Access Compliance Report

Public Rights-of-Way

(Curb Ramps)

Intersection ID: 28462	Main Street: WESTWINDS_CT	Cross Street: LAWING_SCHOOL_RD	Location: S
ADA ID: EE9FF36FFB76	Ramp Type: Directional1	Initial Pass/Fail: Pass	Overall Compliance: No
Codes/Mitigation Info/Possible Solution		Field Measurements/Component Compliance	
Severity Score: 2.5

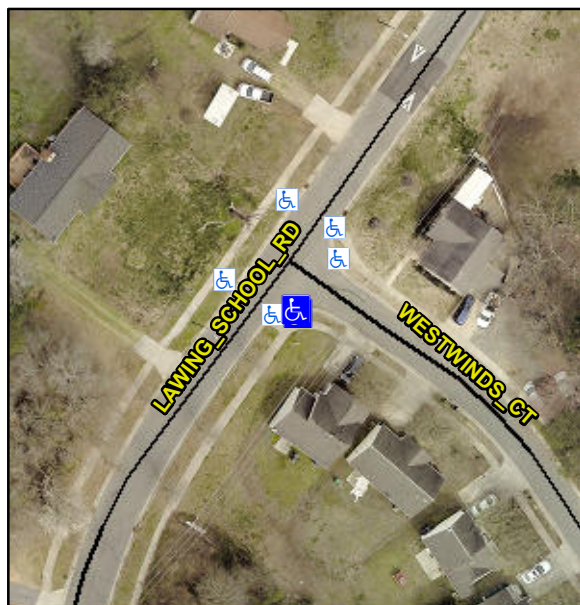
**Not Found, R304.5.3, R305.1.4,
R305.2**

Compliance	Description	Data	Compliance	Description	Data
N/A	Ramp Length (in)	58.0	Yes	Grade Break?	Yes
Yes	Ramp Width (in)	48.0	No	Grade Break Slope (%)	5.7
Yes	Ramp Slope (%)	6.8	Yes	Grade Break XSlope (%)	0.7
Yes	Ramp XSlope (%)	0.5			
Yes	Flare Type LT	N/A	Yes	Flare Type RT	N/A
N/A	Flare Slope LT (%)	N/A	N/A	Flare Slope RT (%)	N/A
N/A	Flare Traversable LT?	No	N/A	Flare Traversable RT?	No
Yes	Landing Length (in)	62.0	Yes	DWS Provided?	Yes
Yes	Landing Width (in)	48.0	Yes	DWS Contrast?	Yes
Yes	Landing Slope (%)	1.2	Yes	DWS Length (in)	24.5
No	Landing X Slope (%)	4.5	No	DWS Full Width?	No
N/A	Landing Curb? (Y/N)	N/A	Yes	DWS Offset LT (in)	25.0
N/A	Shared Landing?	No	No	DWS Offset RT (in)	5.0
Yes	Gutter Ponding?	No	Yes	Gutter Slope (%)	1.3
Yes	Gutter Lip Ht (in)	0.0	No	Gutter X Slope (%)	2.7
N/A	Painted X Walk1?	No		Road Slope (%)	0.4
	X Walk 1 Direction	To N		Road X Slope (%)	3.0
	X Walk 1 Width (in)	N/A		Clear Space?	Yes

**Remove & Replace Entire Ramp.
Remove & Replace Gutter.**
